EGG-EA-6131

ADEQUACY OF STATION ELECTRIC DISTRIBUTION SYSTEM
VOLTAGES, OCONEE NUCLEAR STATION, UNIT NOS. 1, 2
AND 3

J. Emami, Division of Systems Integration, NRR

TAC Nos. 12740, 12741 and 12742

Figure 1. Oconee Electrical Single Line Diagram - Unit 1

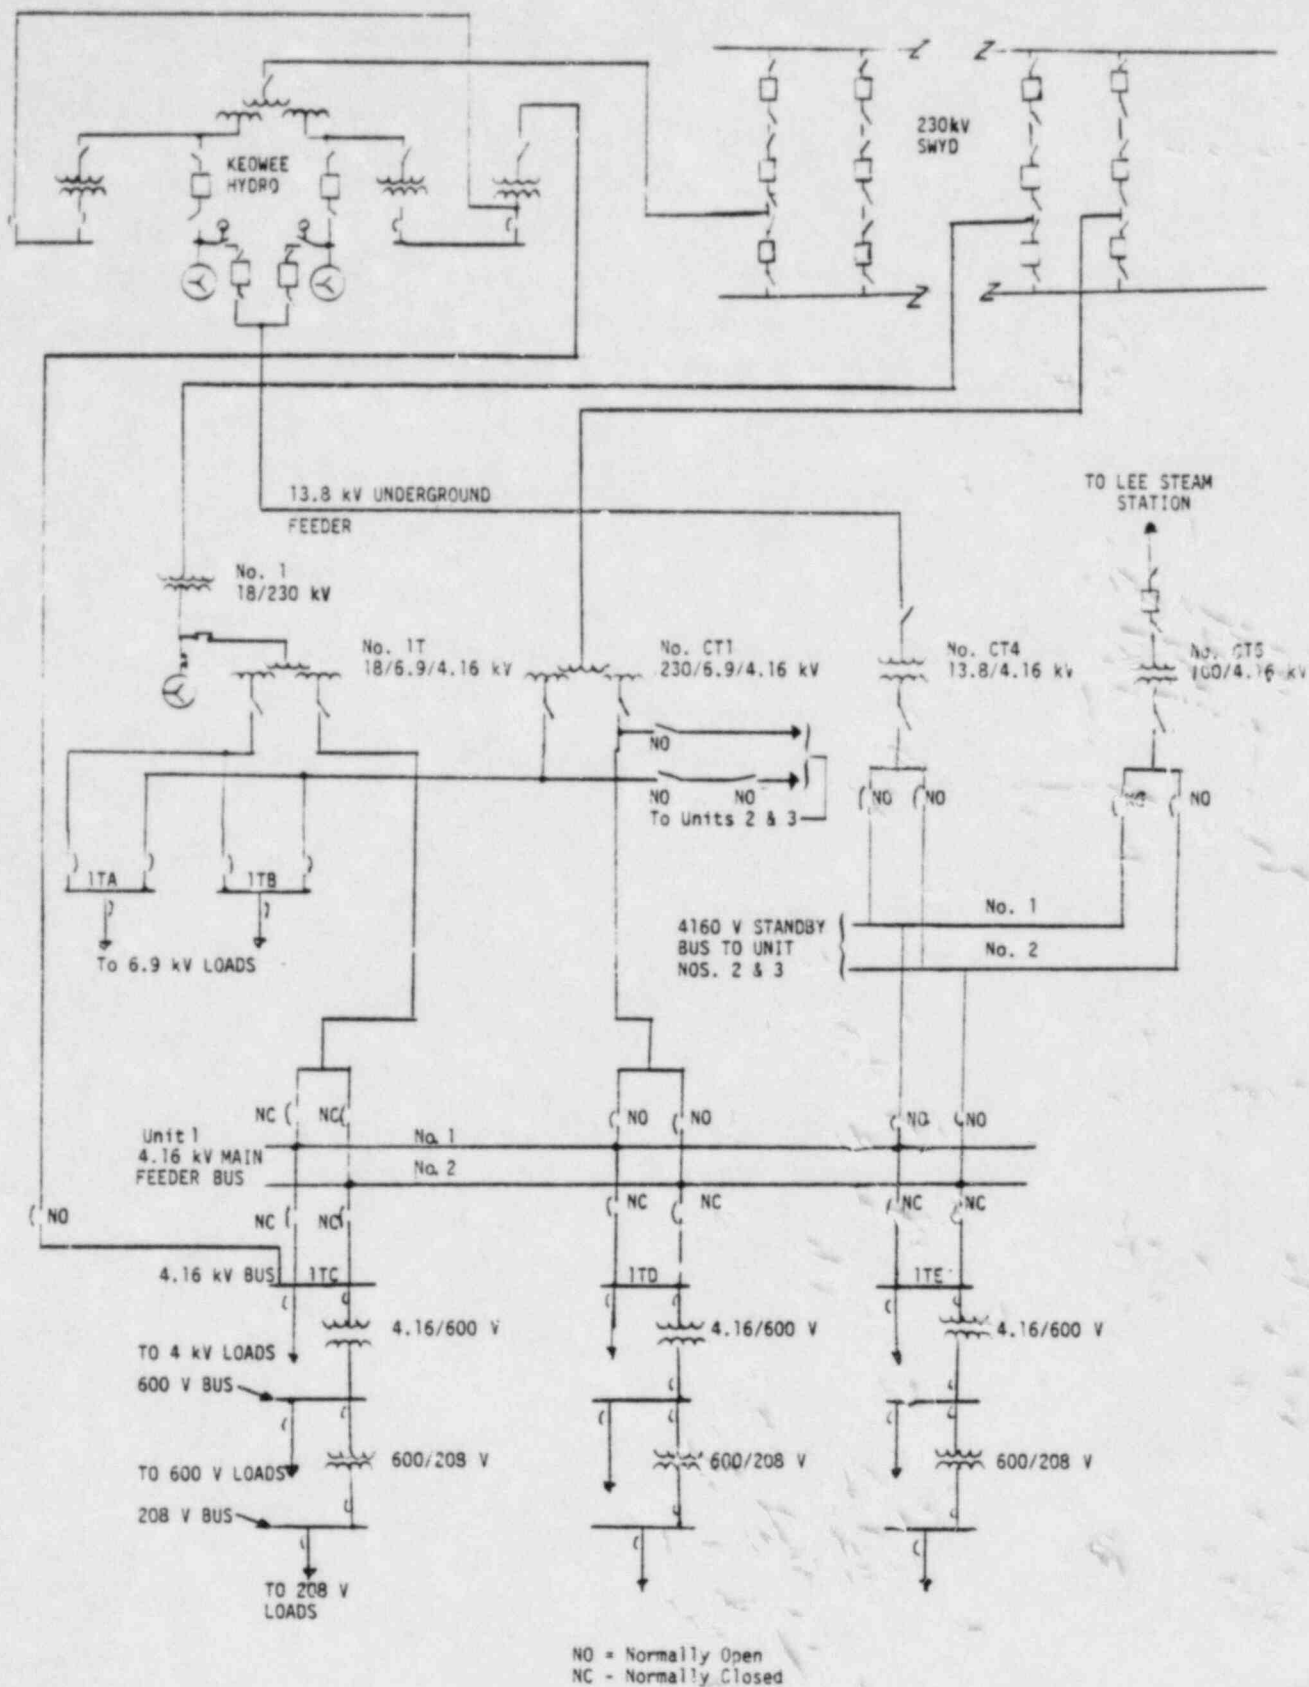
Figure 1 of this report is a simplified sketch of the Oconee electrical single-line diagram. The following description pertains to Unit 1. Unit Nos. 2 and 3 are similar.

During normal plant full-power operation, auxiliary power is supplied by the unit auxiliary transformer No. 1T and during startup and shutdown, by the startup transformer No. CT1 via the 230kV switchyard. Provisions are made for automatic fast transfer of the auxiliary loads from the unit auxiliary transformer to the startup transformer on a unit trip. A second

There are three essential 4.16kV buses; No. 1TC, 1TD, and 1TE. One division of safety-related equipment is powered from each of these buses. Each bus supplies 4kV loads, the 600V load centers and motor control centers (MCCs), and, in turn the 208V MCC's and the 125/250VDC systems.
